Pooks Hill: Sketch Plan Amendment No 32015006A and Site Plan Amendment No. 81982098C

Site Plan Amendment No. 81982098C

Site Plan Amendment No. 81982098C

Figure 4: Proposed Site Plan showing Phase 1 and Phase 2 of development

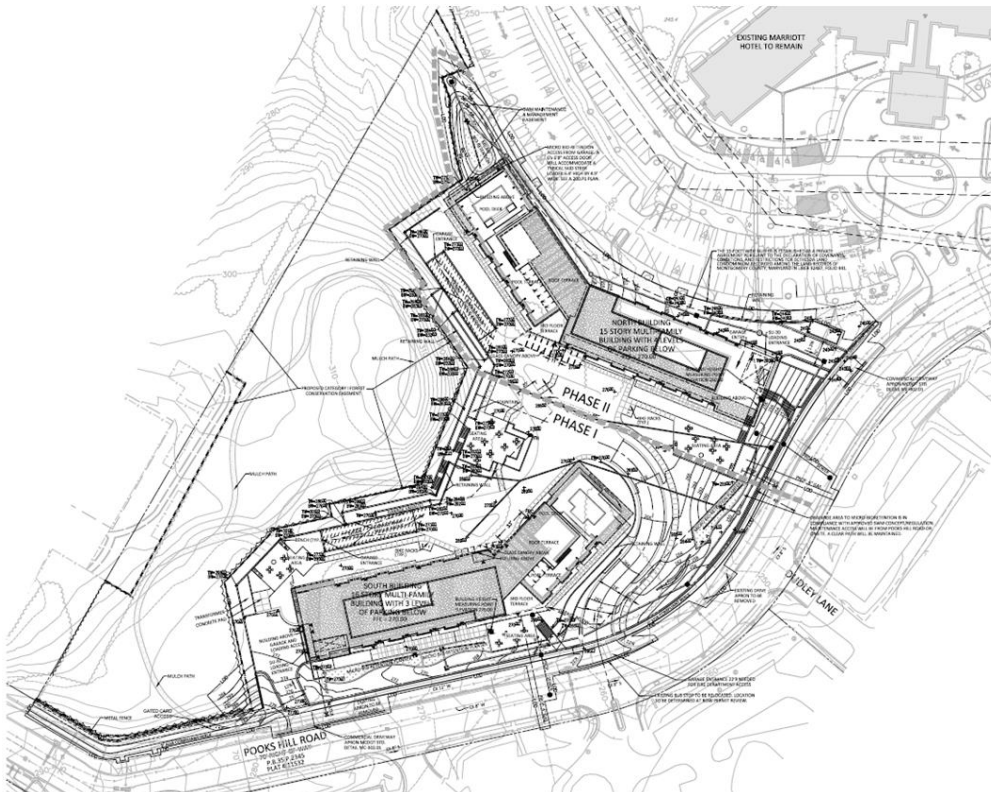
The Site Plan Amendment proposes to redevelop the Property with two multi-family buildings on 6.0 acres of the 19.38-acre tract. The Applicant proposes up to 645,657 square feet of residential uses with up to 631 multi-family residential units, including 15 percent MPDUs (95 units) which will be split between the two buildings. Structured underground parking, on-site amenities will be provided in each building for residents as well as a green area with walking path located in the rear of the multi-family property.

Pooks Hill		
FUTURE MITIGATED GROUND LEVEL NOISE LEVELS		
DWG. No. 2A	PRJ. No. QDC1501	DATE 07-JUNE-16
SCALE NOT TO SCALE		DRAWN BY WCC

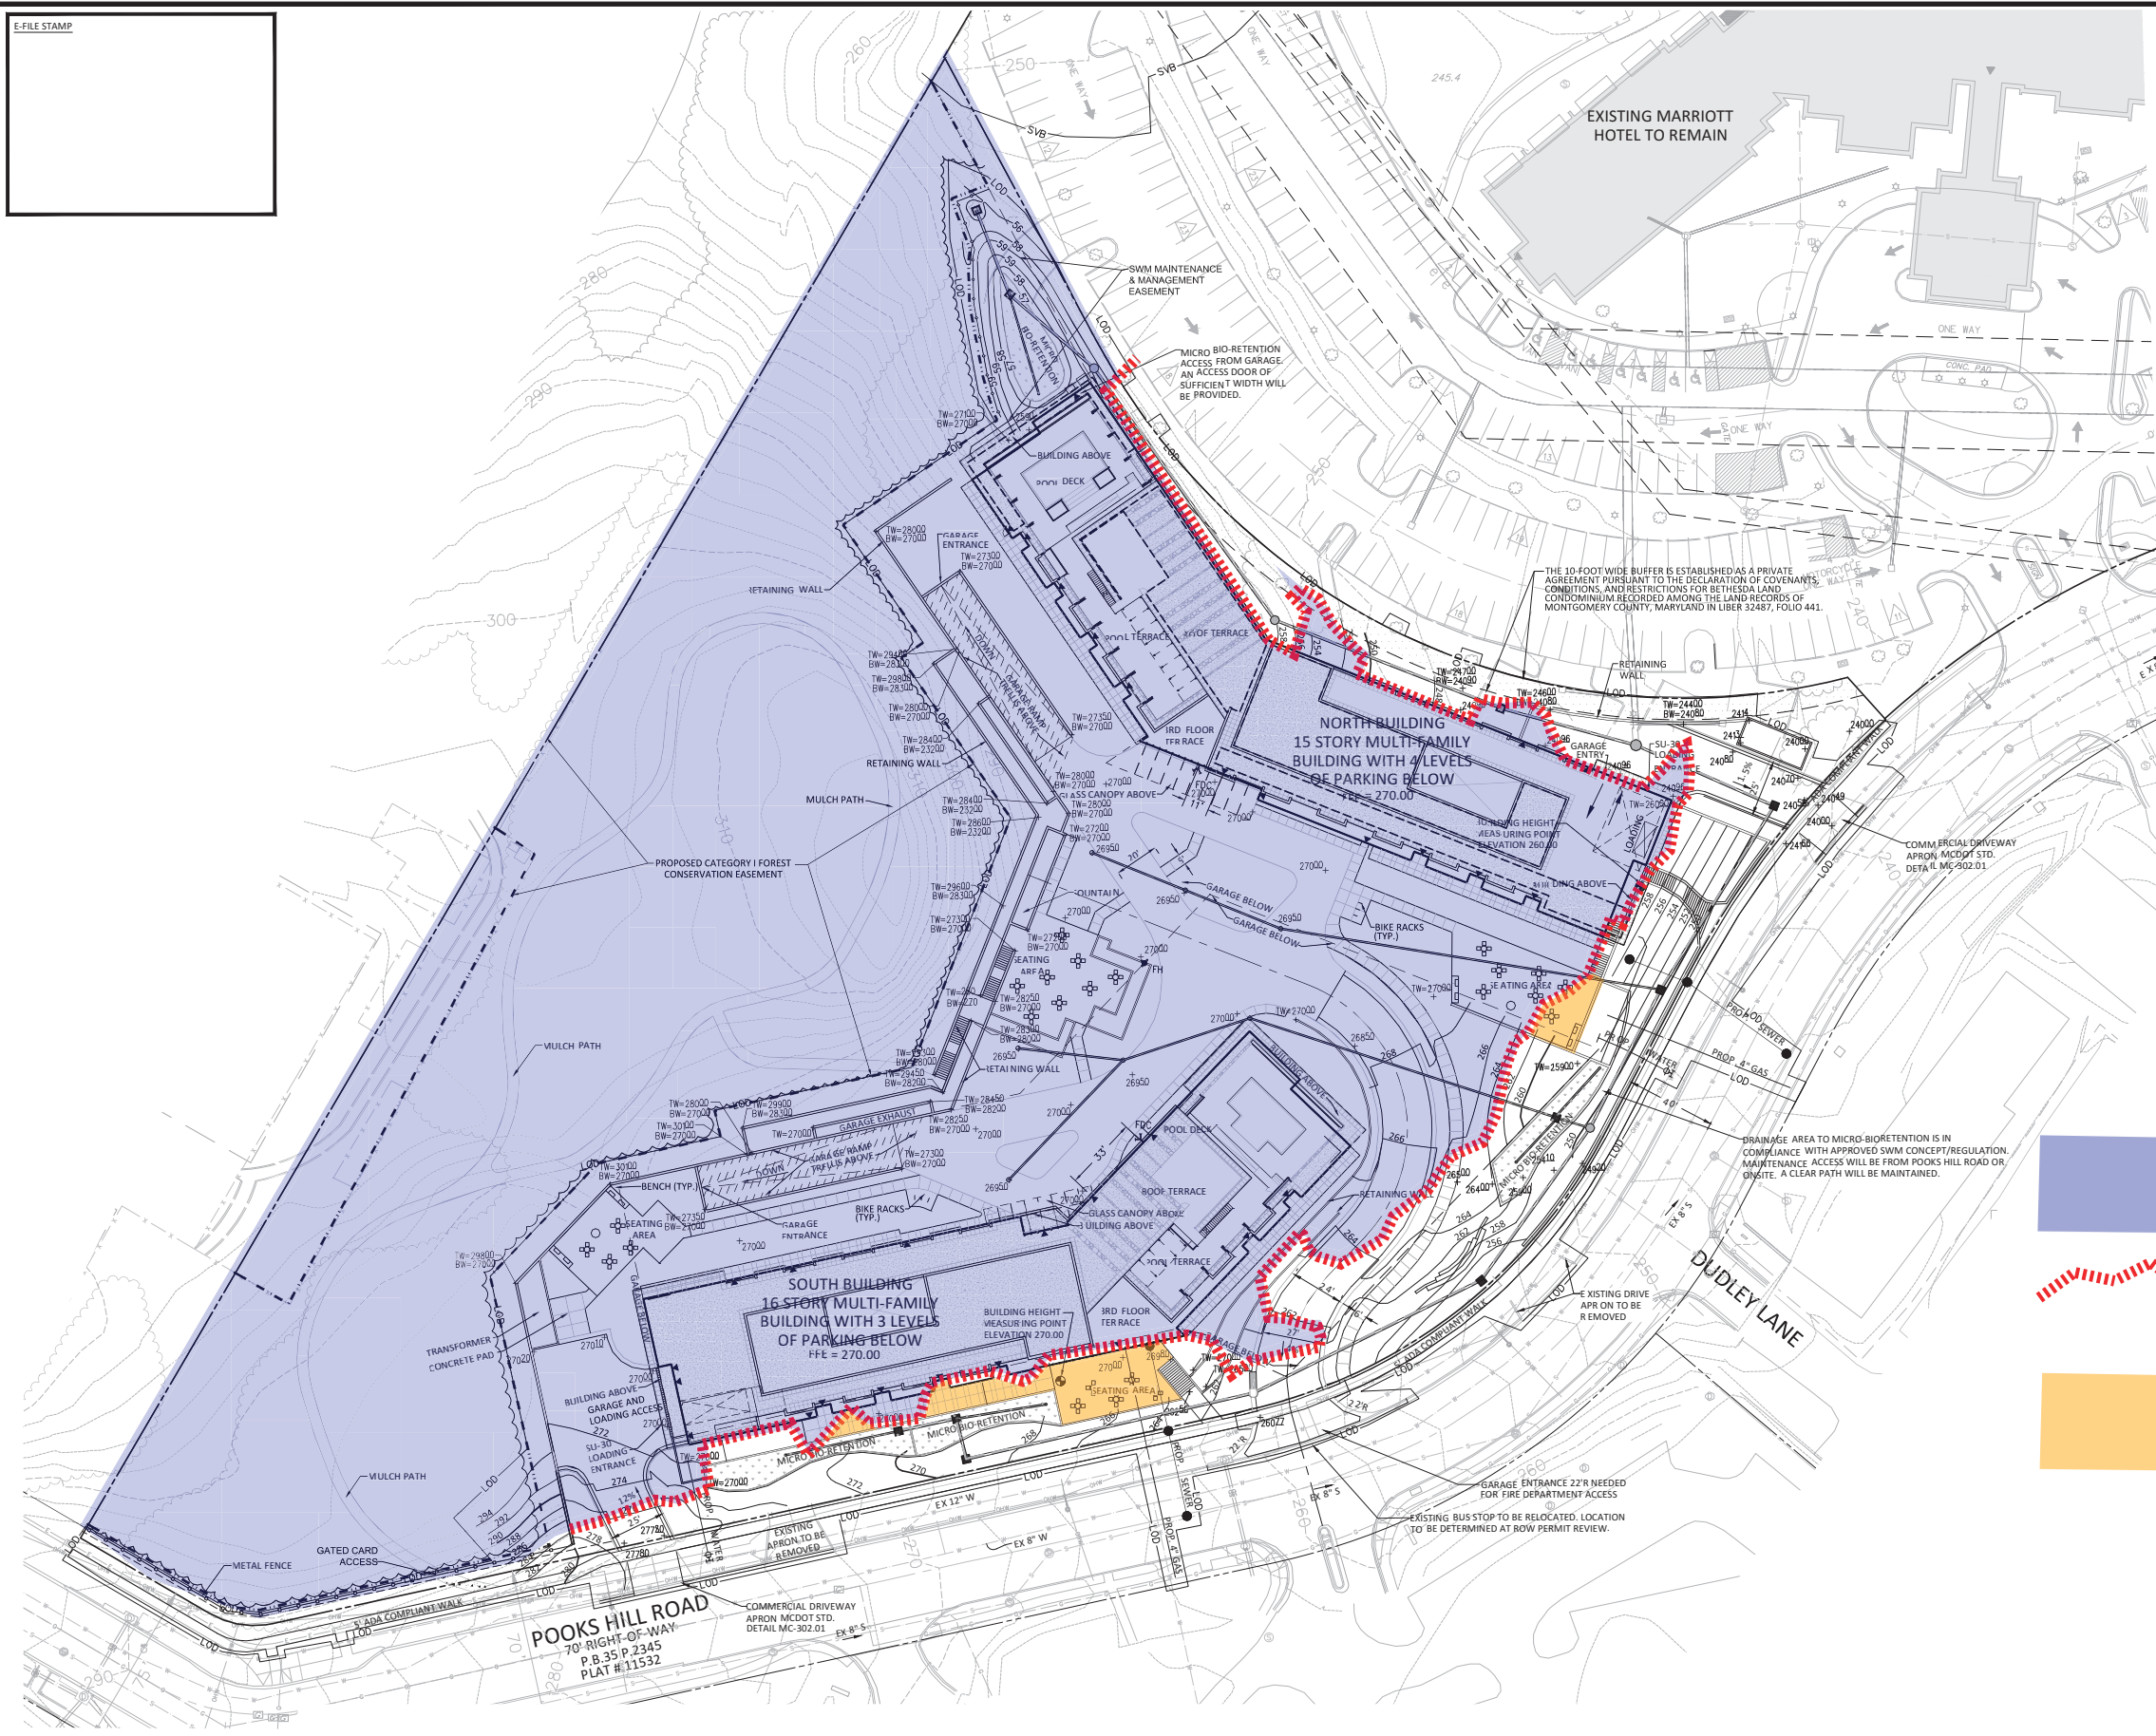
Relative to noise levels in the proposed grade level outdoor activity areas, the Pooks Hill Phase I Noise Analysis determined that noise levels throughout all at-grade outdoor bistro areas would be below 65 dBA Ldn, with the exception of a very small portion of the easternmost bistro area where the noise level will slightly exceed 65 dBA Ldn (at 66 dBA Ldn) due to the close proximity to Pooks Hill Road. See enclosed Drawing 2A, a modified version of Drawing 2 from the Phase I Noise Analysis, in which the at-grade outdoor areas of the site exposed to 65 dBA Ldn are indicated by the blue hatched area. The noise levels shown are "mitigated" noise levels, accounting for the presence of all future site topography, retaining walls, and buildings on noise propagation throughout the site.

While the noise level in a small portion of the easternmost bistro is slightly above the 65 dBA Ldn limit, the exceedance is only 1 dBA, an imperceptible difference as subjectively measured by the human ear. On average, the following describes the human ear’s subjective perception of changes in overall noise level:
